EEE state machine issue

Saied Benyamin (Aquantia)

Jim Graba (Broadcom)

4/16/2019

Valid Alert Starts figure 149-12

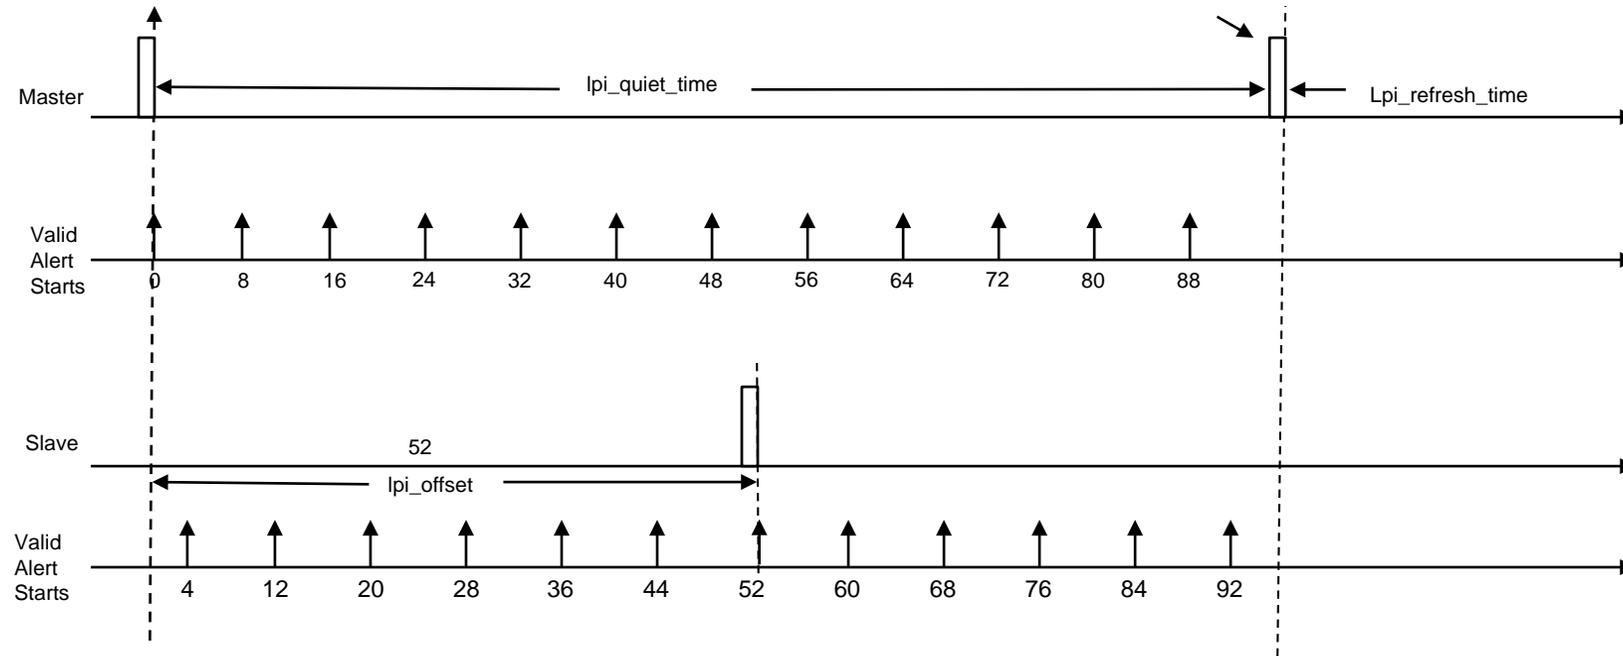
- The EEE machinery is not taking care of the fact that Alert transmission is only allowed to start every 8th RS-Frame.
- An existing variable, tx_alert_start is active on the first frame of alert, but this would be too late for the EEE transmit state machine to change to SEND_ALERT state, we need to change state as the RS-Frame prior to alert ends

- Clause 149.3.5.1: P100, L12, change tx_alert_start to tx_alert_start_next
- Clause 149.3.6.2.2: P103, L5, Remove description of tx_lpi_alert_active
 - In its place add the following description

tx_lpi_alert_start_next

A Boolean variable that is set true on the frame prior to the one that alert transmission can start.

- Calculate value for tx_alert_start_next on page 100 as per tables on slide 4
- Change the PCS State machine as per slide 5
- Change the EEE state machine as per slide 6
-

Figure 149–15—PCS 64B/65B Transmit state diagram, part b

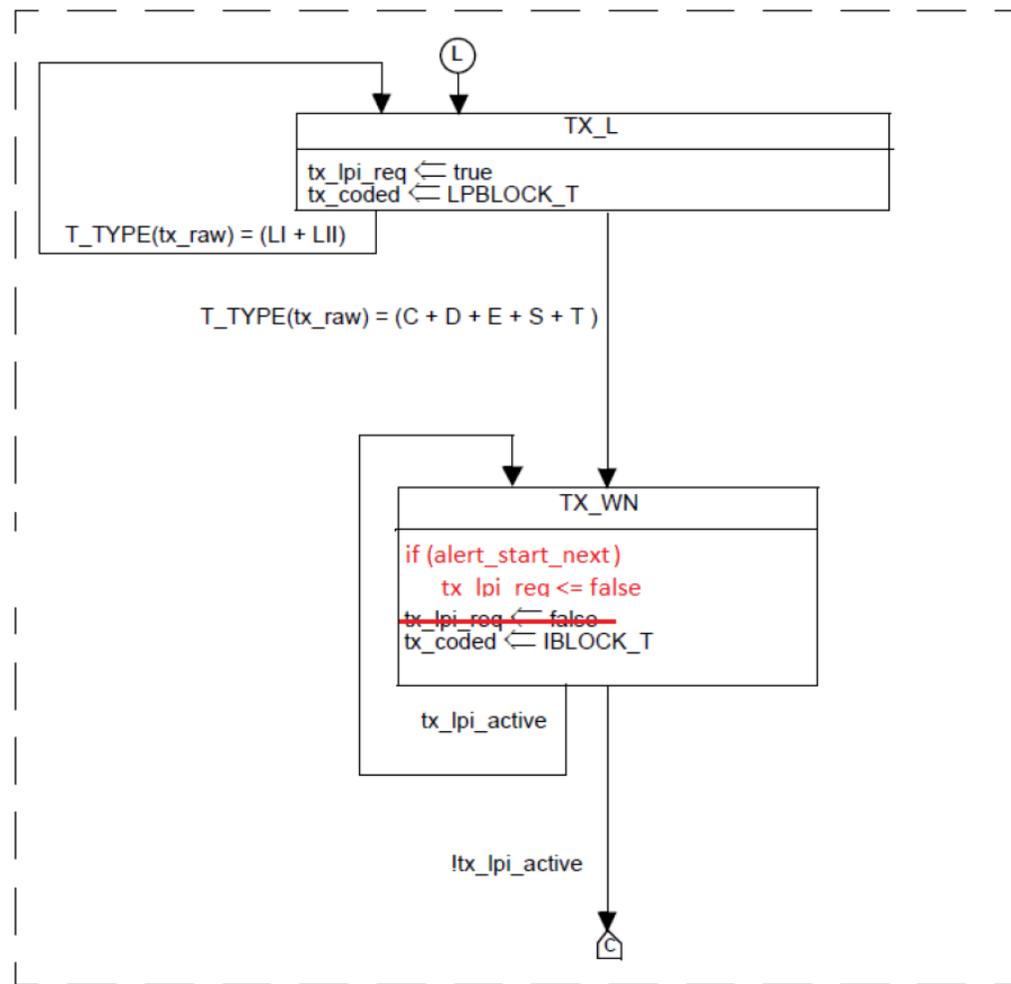
Changes to PCS transmit state machine P110 L9
